Agenda Item #3: ~~HPPB~~ 21-0457: 1 Lincoln Road and 1671 Collins; Ritz-Sagamore

Request to Deny Certificate of Appropriateness (COA) for Ritz- Carlton (DiLido) | Sagamore Supplemental Handout on Rooftop Addition Prohibition

December 13, 2021

1. Applicant Plan Sheet (A0.56)

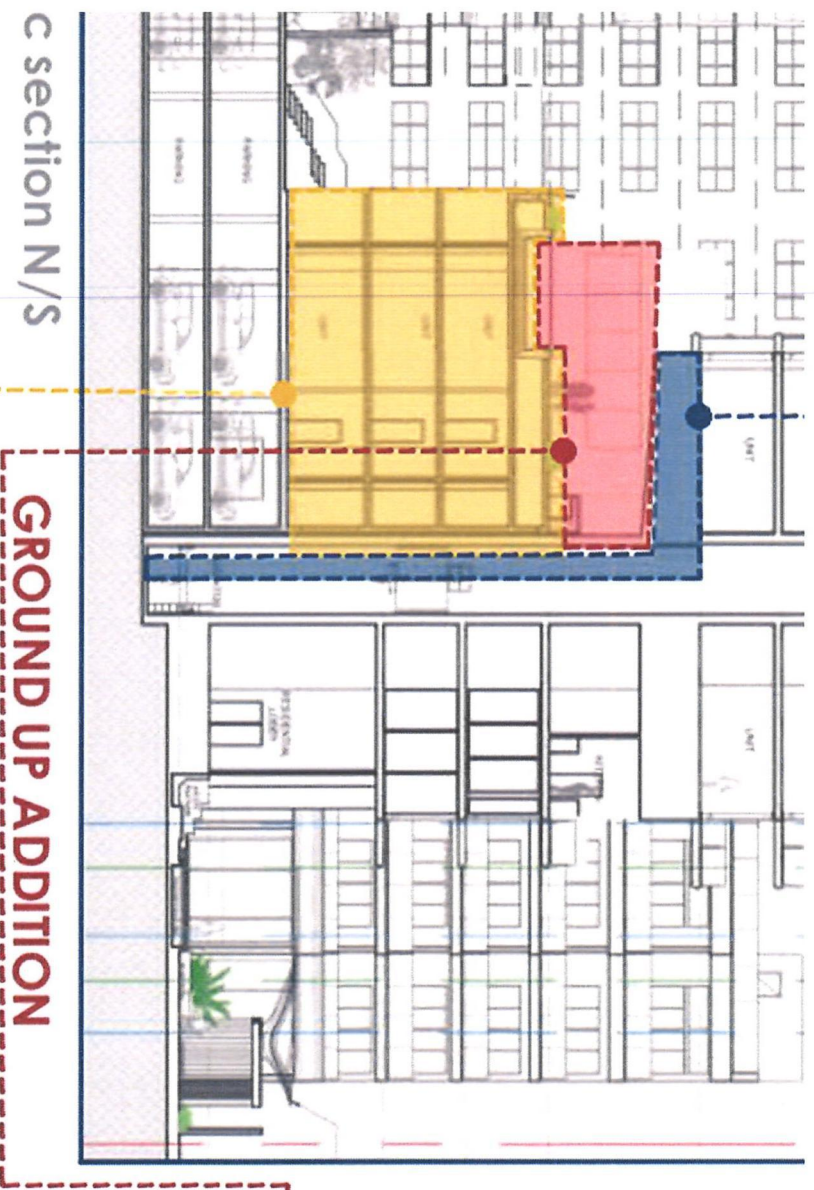
The Applicant Proposes a One-Story Fifth-Floor Addition on Top of the North Ritz Cabana Building

Applicant Plan Sheet (A4.31).

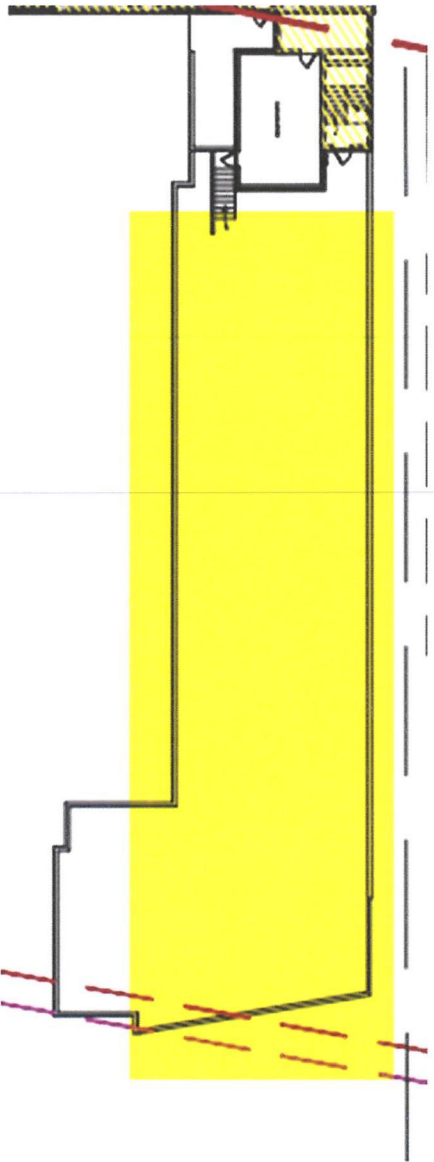
South Elevation Proposed Tower Labelled in Plans: “One Story Addition Over Existing Building”

Existing FAR Fifth Floor Plan Sheet A1.05:

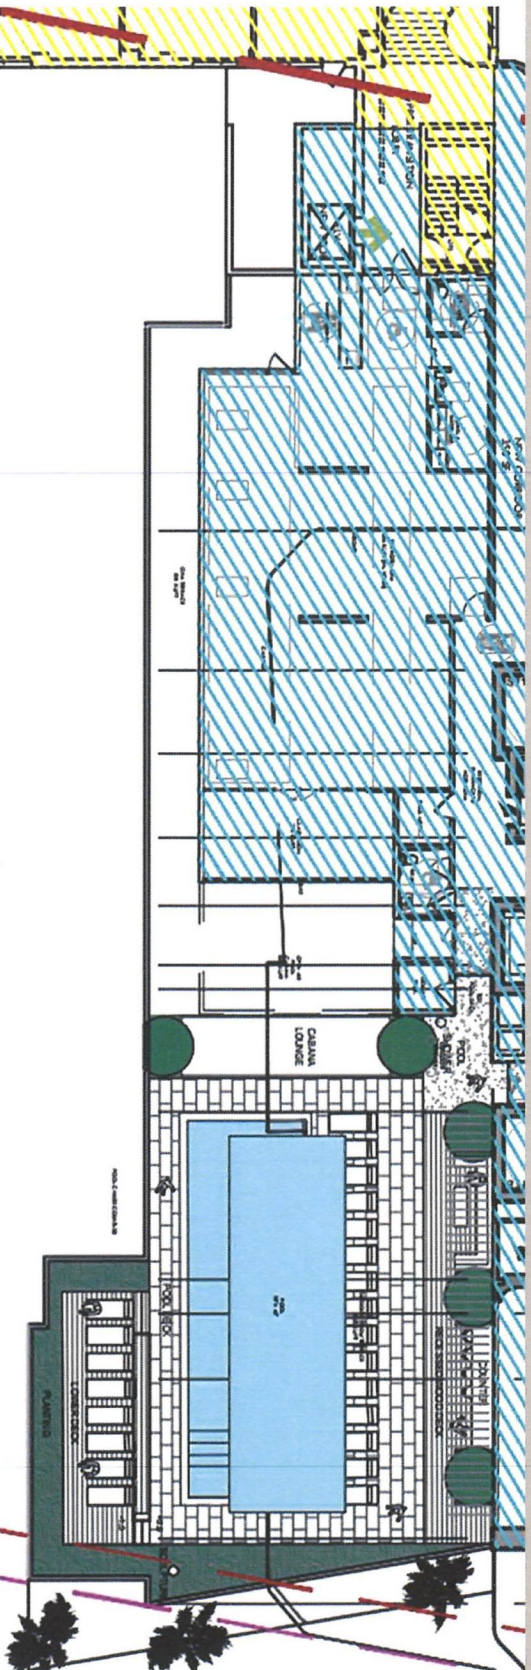
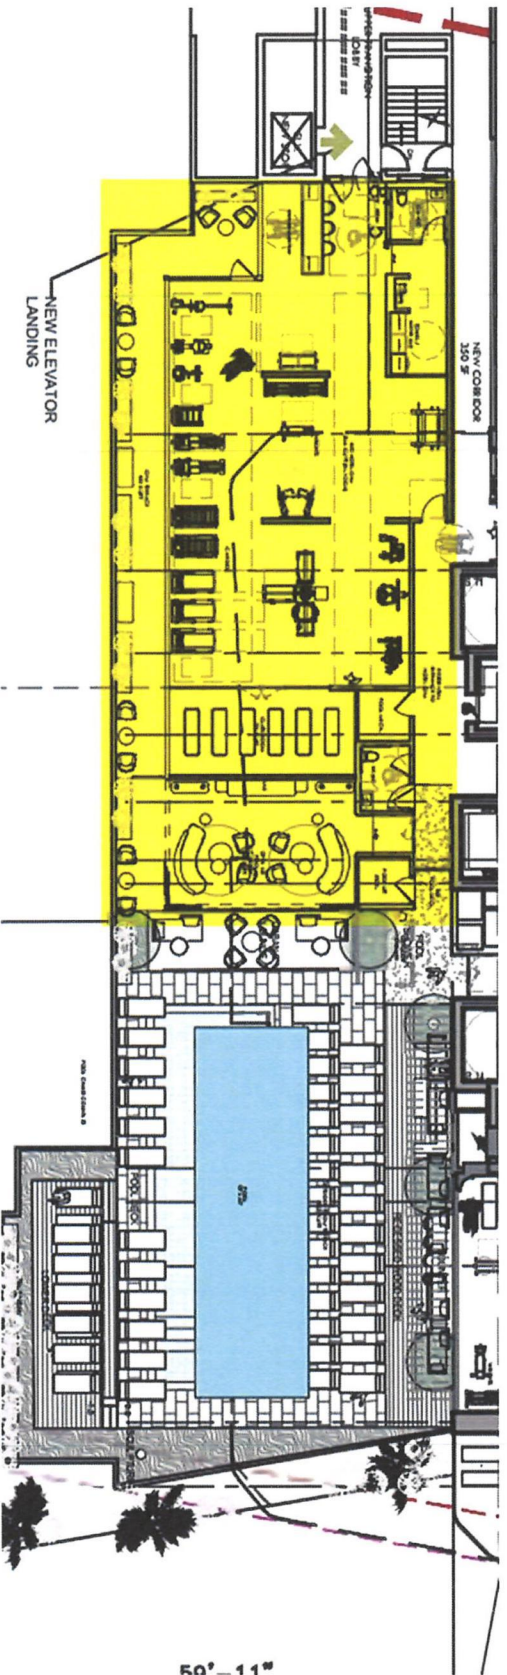
The Existing FAR sheet shows no FAR on the North Cabana Rooftop.

Rooftop Addition

From the existing generator room located to the left, all the way out along the top of the north cabana wing of the Ritz, the Applicant proposes an enclosed fitness center gym, and an open pool deck.

Proposed Tower Floor Plan: Fifth Floor Plan Sheet A2.05

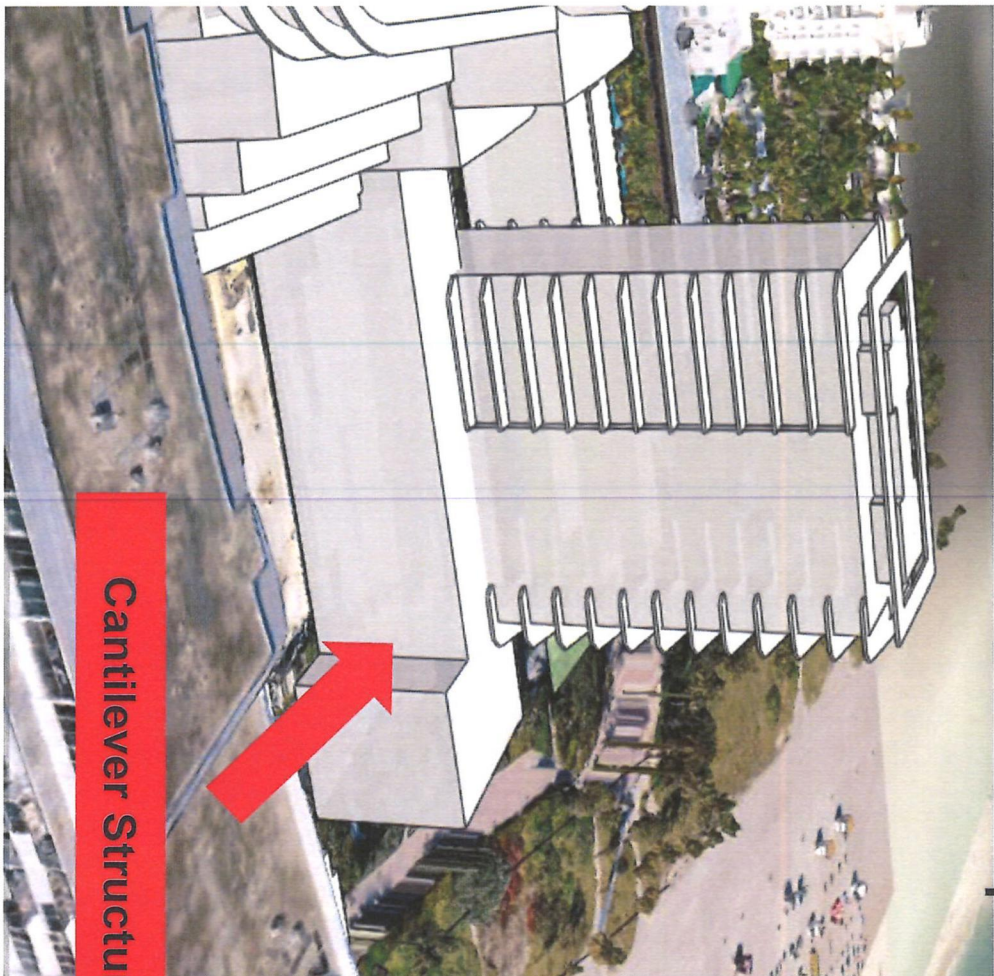
Rooftop Addition Variance Issue

The Fifth-Floor Addition and other Tower Improvements that tie into the existing Ritz-Carlton north cabana wing roof present a violation of the rooftop addition prohibition.

Even if the rooftop addition variance was properly identified, the Applicant could not seek it, as the Code states “no variance” may be granted.
